## Second Response to Issues raised on the NHM-10X FCC Application

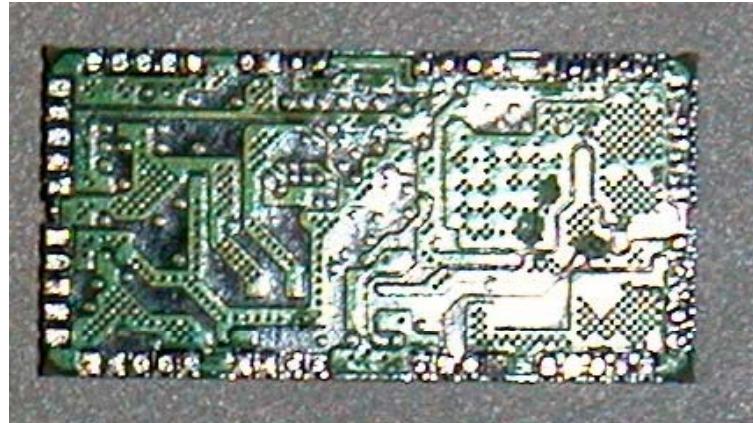
1) We did not realize that the Bluetooth was a installed module. Part 15 (bluetooth approval) requires the top and bottom of each board photographed. Please provide an additional bottom photograph of the module.

Response 1) As requested, an image of the underside of the Bluetooth Module is shown below.
